Access Compliance Report

Public Rights-of-Way

(Curb Ramps)

Intersection ID: 49397	Main Street: HERFORD_ST	Cross Street: DAMASCUS_ST	Location: SE
ADA ID: 8AE8D2DA8D51	Ramp Type: PerpDiag	Initial Pass/Fail: Fail	Overall Compliance: No
		Severity Score: 21.25

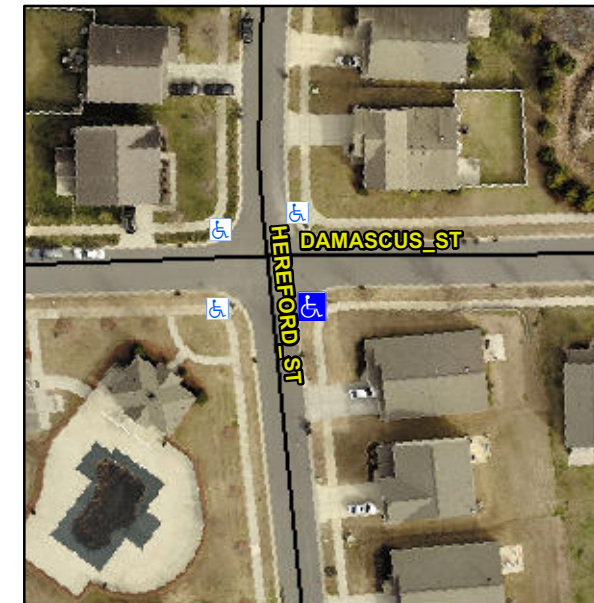
Not Found, R304.5.1, R304.5.3

Compliance	Description	Data	Compliance	Description	Data
N/A	Ramp Length (in)	73.5	Yes	Ramp Slope (%)	6.2
No	Ramp Width (in)	47.0	No	Ramp XSlope (%)	6.3
N/A	Flare Type LT	N/A	N/A	Flare Type RT	N/A
N/A	Flare Slope LT (%)	N/A	N/A	Flare Slope RT (%)	N/A
N/A	Flare Traversable LT?	N/A	N/A	Flare Traversable RT?	N/A
N/A	Landing Length (in)	N/A	N/A	DWS Provided?	N/A
N/A	Landing Width (in)	N/A	N/A	DWS Contrast?	N/A
N/A	Landing Slope (%)	N/A	N/A	DWS Length (in)	N/A
N/A	Landing X Slope (%)	N/A	N/A	DWS Full Width?	N/A
N/A	Landing Curb? (Y/N)	N/A	N/A	DWS Offset (in)	N/A
N/A	Shared Landing?	N/A			
N/A	Gutter Ponding?	N/A	N/A	Gutter Slope (%)	N/A
N/A	Gutter Lip Ht (in)	N/A	N/A	Gutter X Slope (%)	N/A
N/A	Painted X Walk1?	No	N/A	Painted X Walk2?	No
	X Walk 1 Direction	To N		X Walk 2 Direction	To W
N/A	X Walk 1 Width (in)	N/A	N/A	X Walk 2 Width (in)	N/A
	X Walk 1 Slope (%)	1.8		X Walk 2 Slope (%)	1.8
	X Walk 1 X Slope (%)	0.2		X Walk 2 X Slope (%)	2.1

Remove & Replace Curb Ramp With Two New Directional Ramps or Equivalent.
